Local Planning Panel

Agenda

- 1. Disclosures of Interest**
- 2. Confirmation of Minutes**
- 3. Development Application: 16-22 Cooper Street, Surry Hills - D/2025/1198**
- 4. Development Application: 41 and 43 Albion Street, Surry Hills - D/2026/262**

Figure 23: 3D perspective of the proposed development showing the 27m height plane

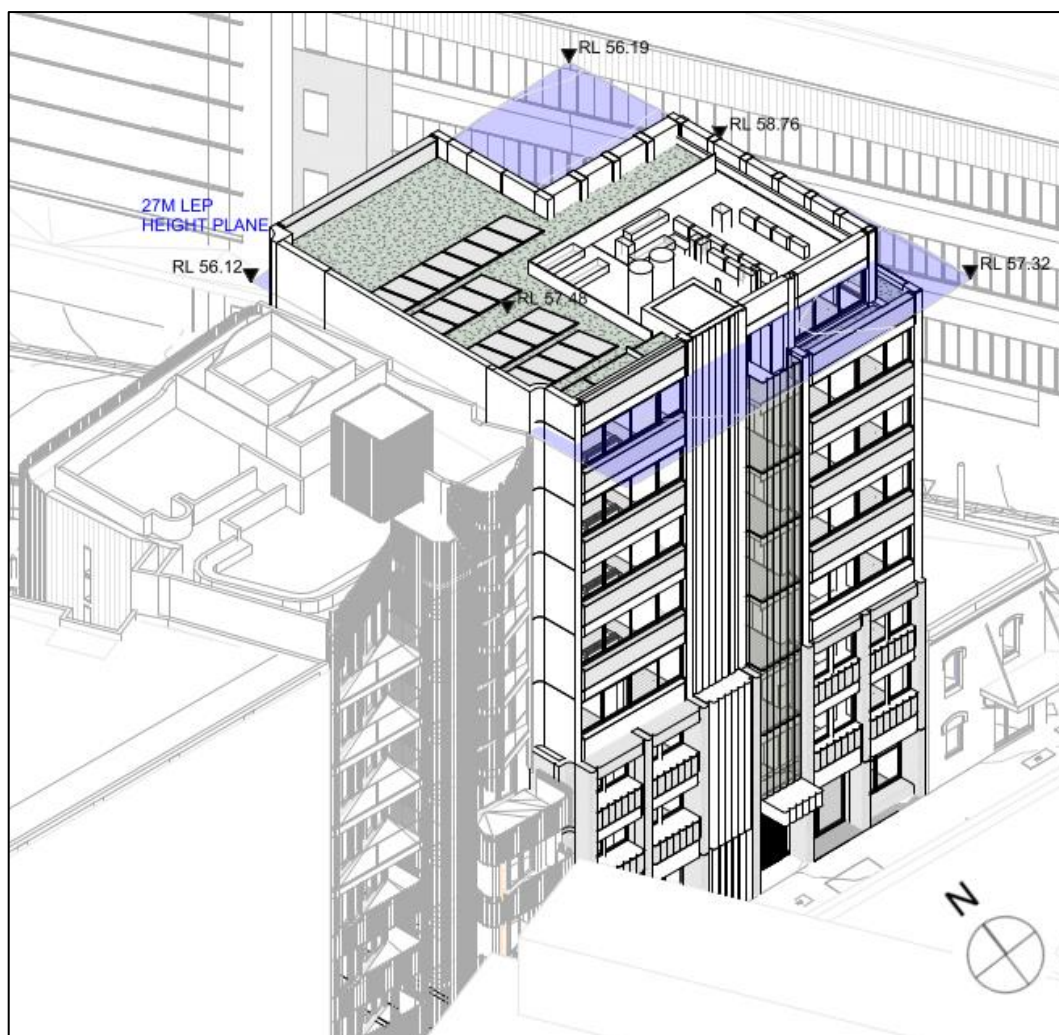
62. The site is subject to a maximum height control of 27m.
63. The proposed development exceeds the height control, with a maximum height of 29.7m above existing ground level to the top of the lift overrun and roof parapet (RL 58.76), resulting in a variation of 2.7m or 10% from the development standard.

Figure 24: 3D aerial view of surrounding context

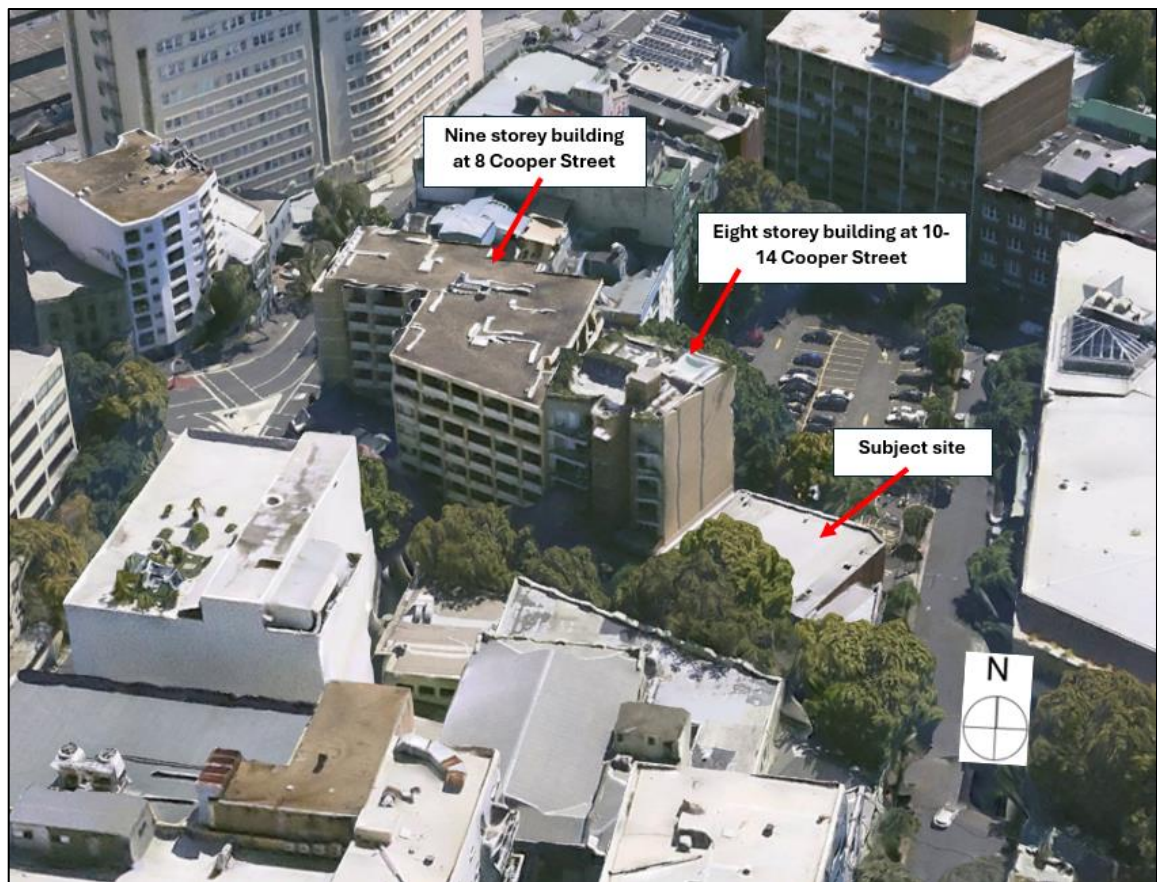
- (a) The overall height of the proposal is appropriate within the context of the site and surrounding development, including adjoining the 8 storey mixed-use building at 10-14 Cooper Street (approved by the LEC under D/2016/684), and the 9 storey mixed-use building further west on the corner of Cooper Street and Elizabeth Street. It is noted that although the overall height of the proposed development is similar to the height of the neighbouring properties at No.10-14, and No.8, the RLs of the proposal are higher due to the slope of the street falling to the west. The context of the surrounding buildings is shown in the below figure.

Figure 27: Ground floor plan showing the location of the communal area

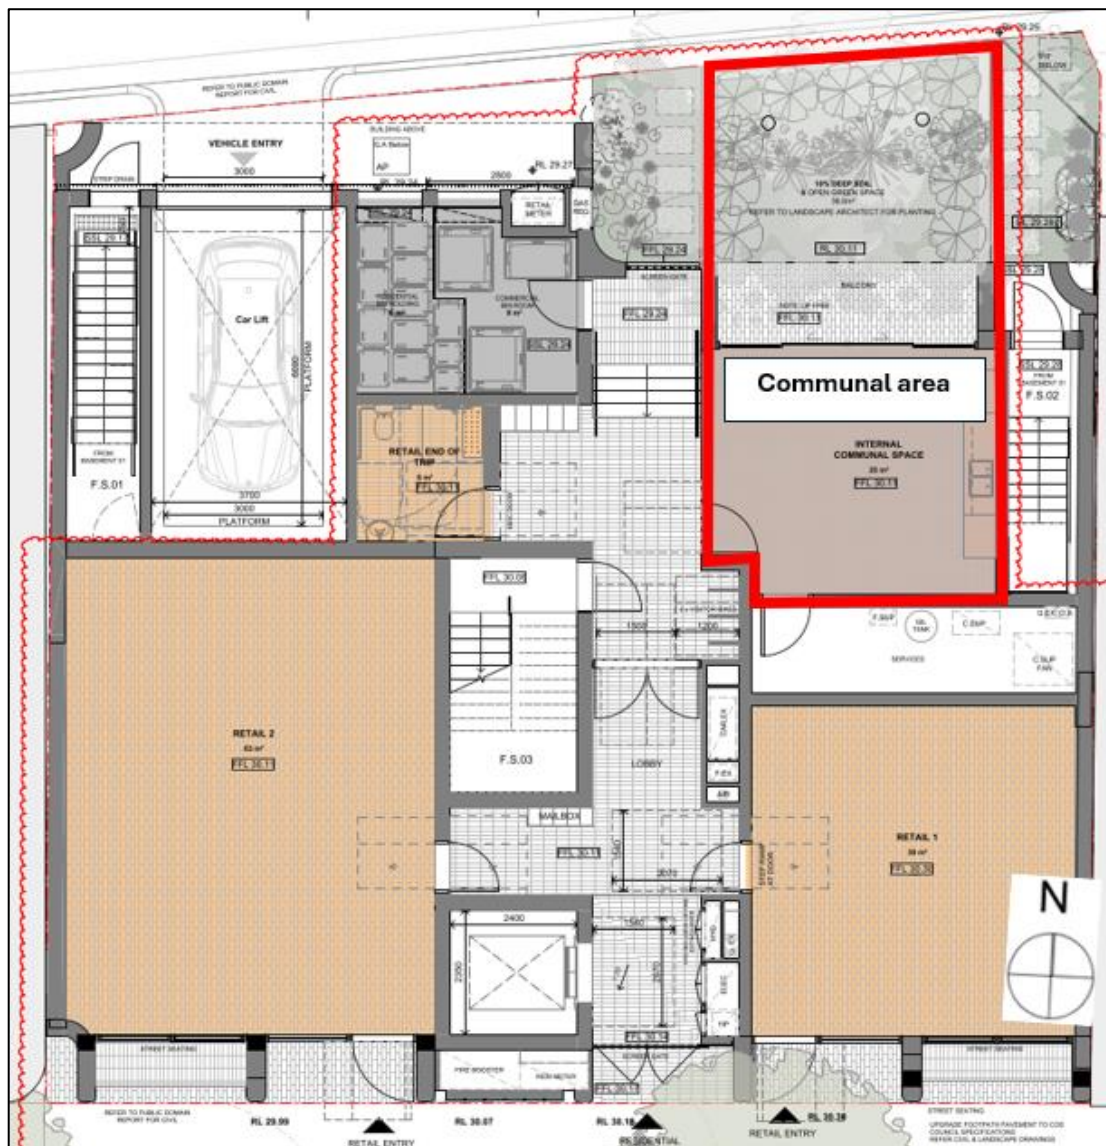
71. The proposed development includes a communal area at ground floor level in the north-eastern portion of the site. The communal area comprises an internal space of 25 sqm, and a landscaped outdoor area of 28 sqm, for a total area of 53 sqm, which equates to 14% of the site area. This area is outlined in the below figure.

Figure 29: View from the sun diagram at 11am mid-winter

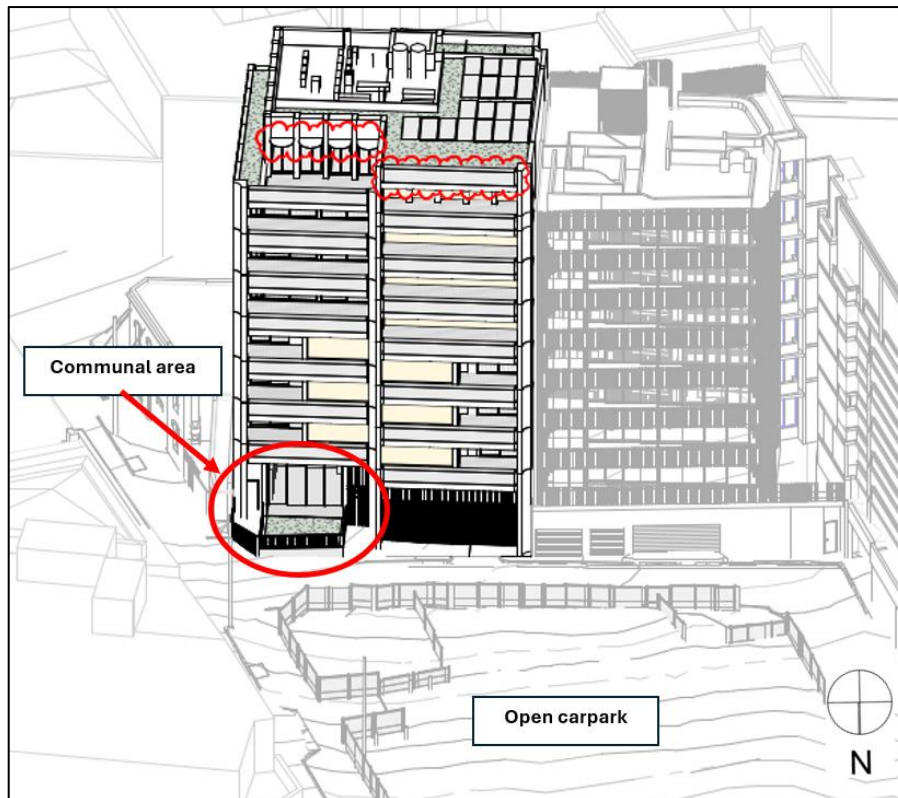
72. The submitted shadow diagrams indicate that the communal area will receive direct sunlight to at least 50% of both the indoor and outdoor space from 11am to 2pm mid-winter. Whilst this strictly complies with ADG requirements for solar access, it is noted that any future development of the open carpark to the north will reduce the amount of direct sunlight to the communal areas. This is demonstrated in the below figures.

Figure 31: Ground floor waste holding area fronting O'Loughlin Street

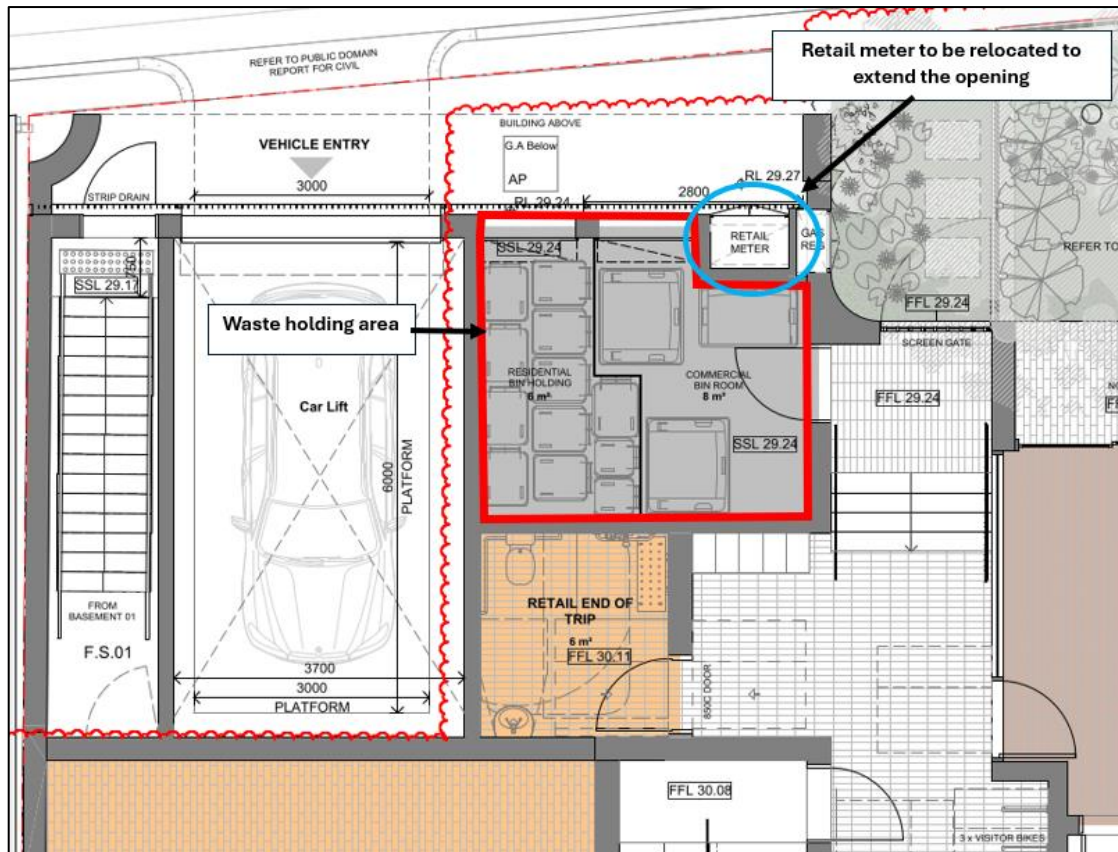
79. Council's Cleansing and Waste Management Team have advised that whilst the location of the waste holding area is acceptable, the space provided is insufficient to allow each waste stream to be wheeled out independently. As the 3 waste streams will not be serviced simultaneously, each stream must be able to be serviced independently without requiring bins to be moved or rearranged. A condition of consent is recommended requiring the waste holding area to be reconfigured and for the rear external opening to be widened by removing or relocating the retail meter, to allow for improved access and sufficient circulation space for each waste stream to be wheeled out and serviced independently. See below figure.

Figure 32: Cooper Street elevation, showing the change in architectural expression above and below the street wall

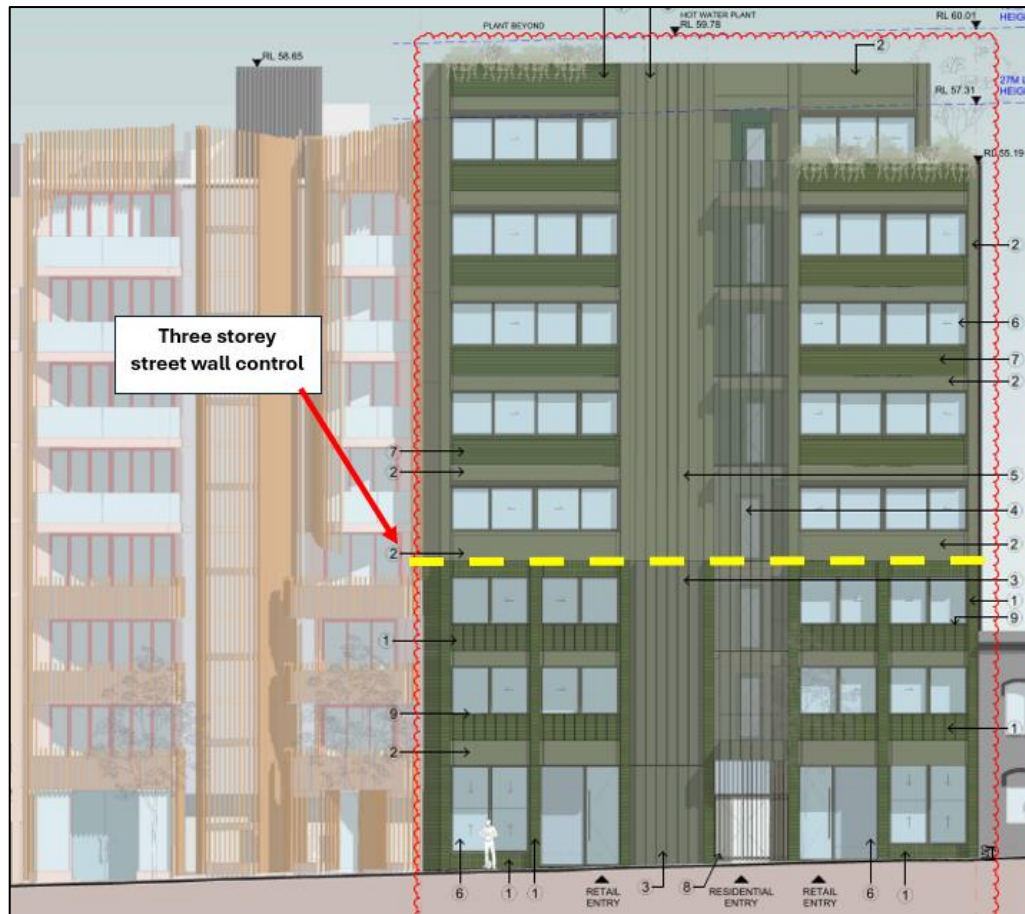
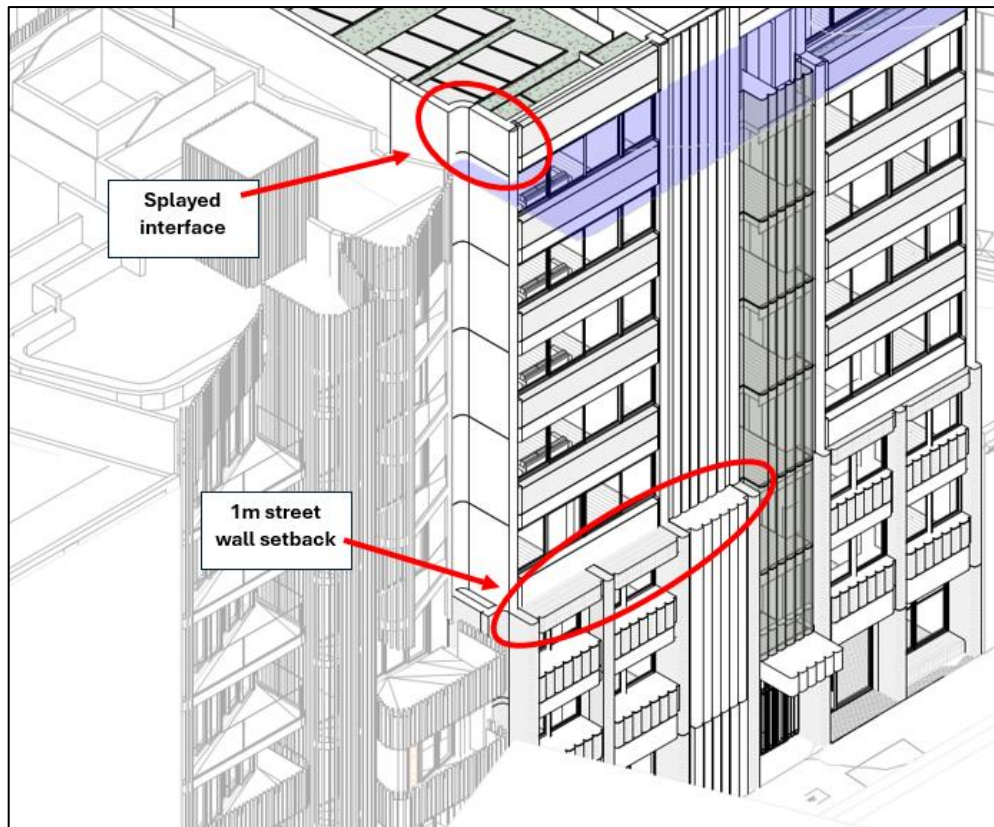
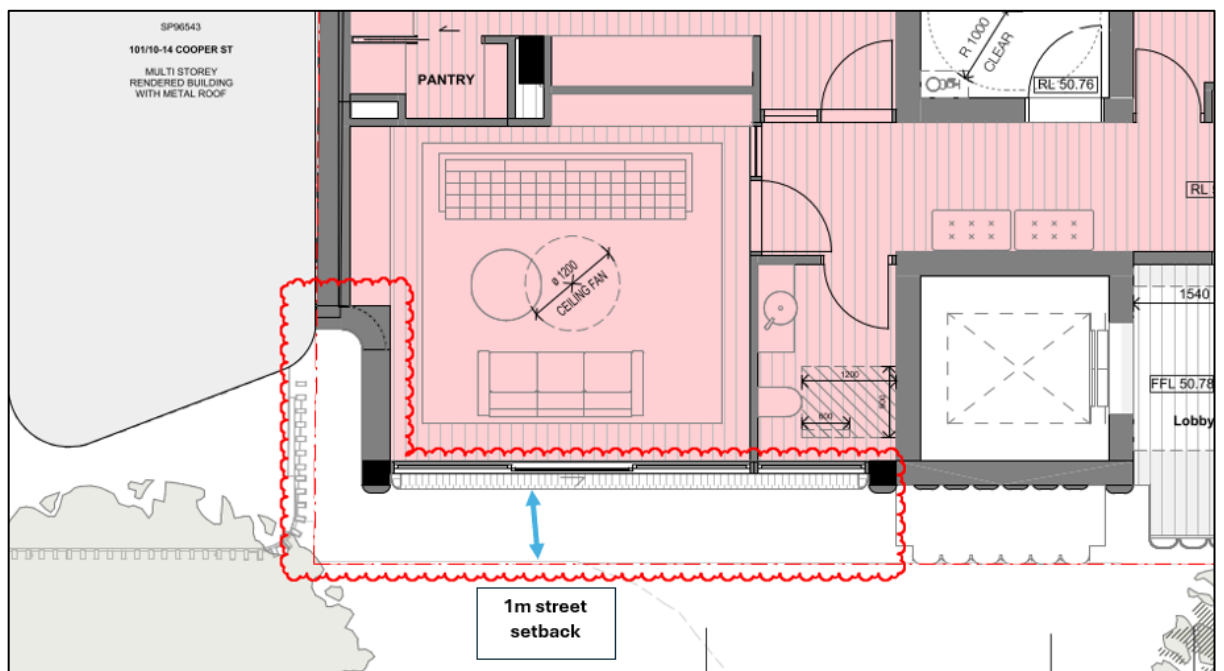
Response: The materiality and architectural expression of the Cooper Street facade has been amended to better acknowledge the 3 storey street wall DCP control and respond to the street setbacks of the neighbouring building at 10-14 Cooper Street. The western portion of the Cooper Street facade is setback 1m from the street boundary above the 3 storey street wall and features a splayed interface with No.10-14 Cooper Street. This is demonstrated in the below figures.

Council's Urban Designer supports the facade design, subject to additional details being provided for the terrazzo window sills, and for the glazed green brick balustrades to incorporate a stone or masonry capping to the top of the balustrade. A condition of consent is recommended to capture these recommendations.
